WORK PLAN FOR MUNITIONS RESPONSE FOR DISCARDED MILITARY MUNITIONS AT
BUILDING 365 AND HANGAR 860 NAS CECIL FIELD FL
10/18/2011
CH2M HILL

WORK PLAN REVISION

REVISION NO: 02

Explosives Safety Submission, Amendment No. 05

FIGURE C-1
Quantity-Distance Map
of MGFD for Initial MRS
Expansion No. 4 of
Building 365 MRA

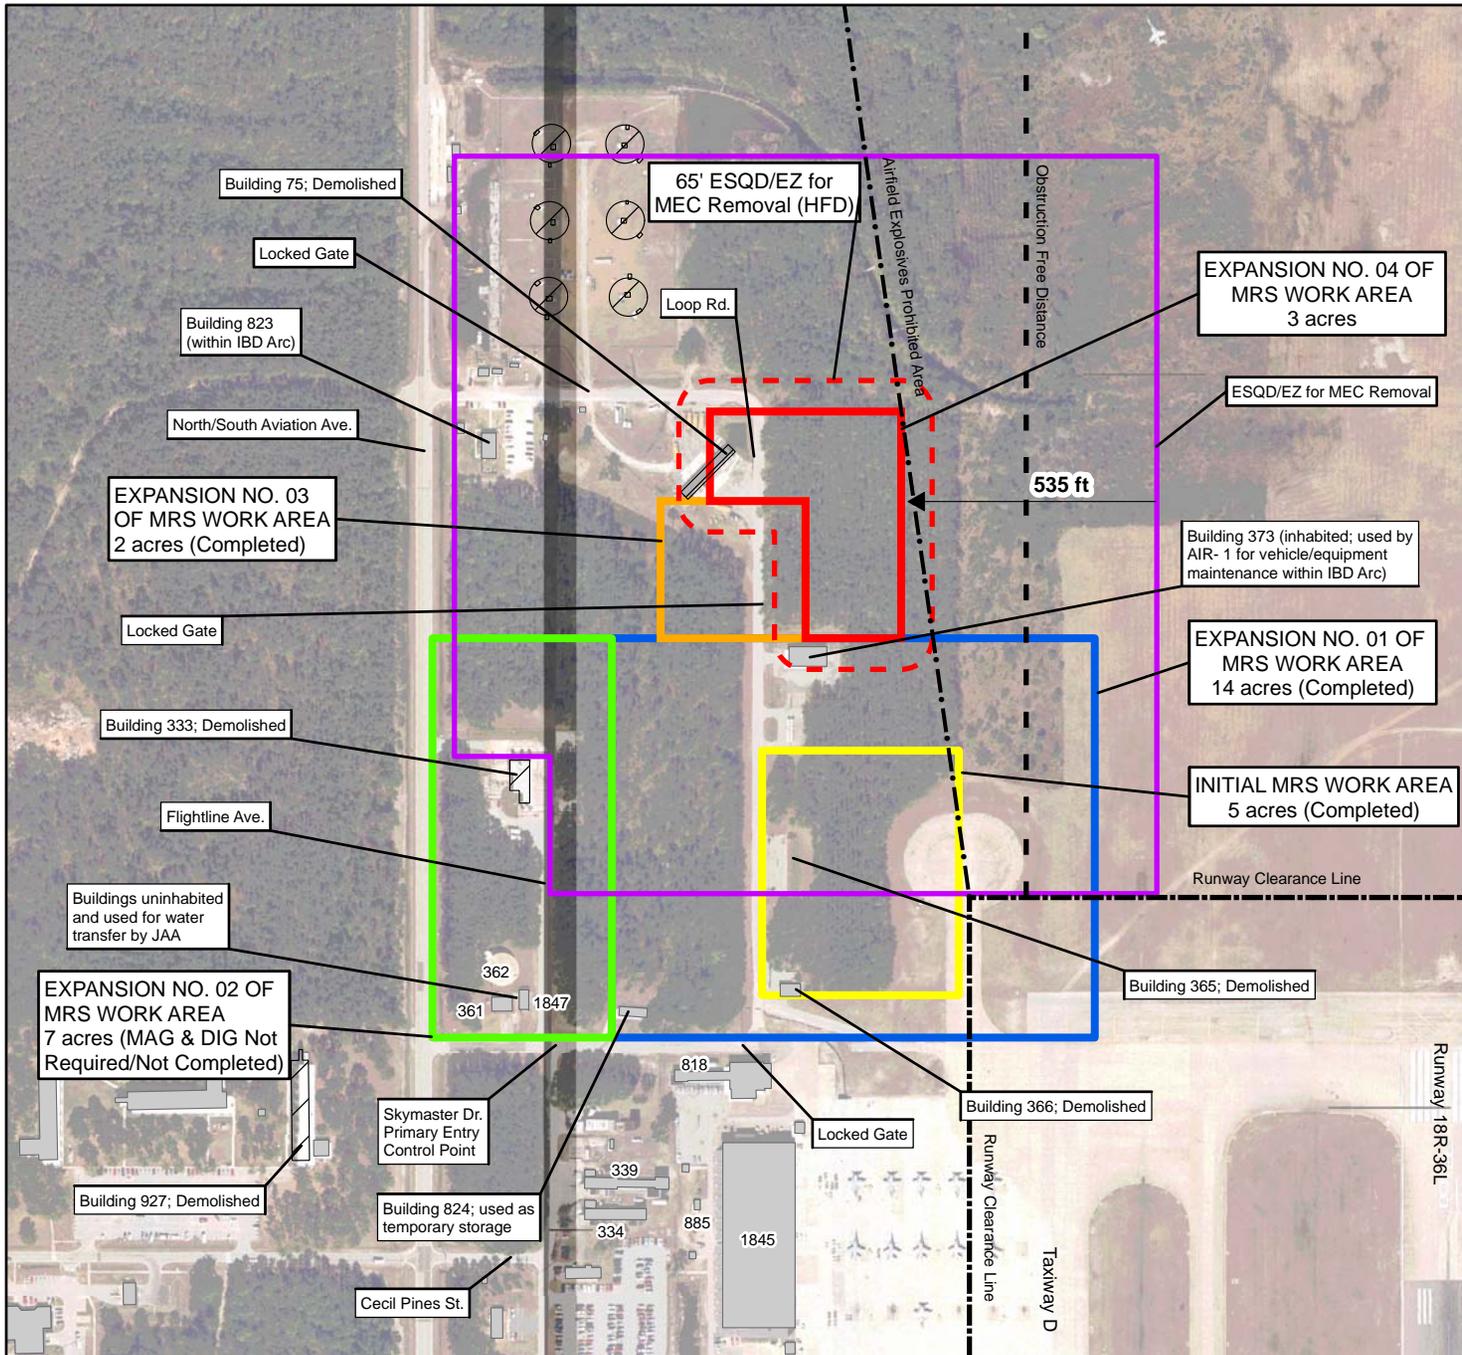
Item No.	Reasons for the Modifications/Revisions
001	Explosives Safety Submission, Amendment No. 05 reflects the adjustment in explosives safety quantity-distance (ESQD) arc for the M56A4 20-millimeter (mm) high explosive (HE) round resulting from the May 24, 2011 update of the Department of Defense Explosives Safety Board (DDESB) Fragmentation Data Review Forms. Per Naval Ordnance Safety and Security Activity (NOSSA) Instruction (NOSSAINST) 8020.15C (NOSSA, 2011), amendments are required when a change to an approved ESS increases explosives safety risks, identifies requirements for additional or increased explosives safety controls, or changes an ESQD arc.
002	Explosives Safety Submission, Correction No. 01 includes an update to Appendix B-1 to reflect the May 24, 2011 update of the DDESB Fragmentation Data Review Forms and a revised Appendix B-2 per the Appendix B-1 update for the 20-mm M56A4 HE round. Per NOSSAINST 8020.15C (NOSSA, 2011), corrections are required when a proposed change to an approved ESS does not increase explosives safety risks, identify requirements for additional or increased explosives safety controls, or changes an ESQD arc.
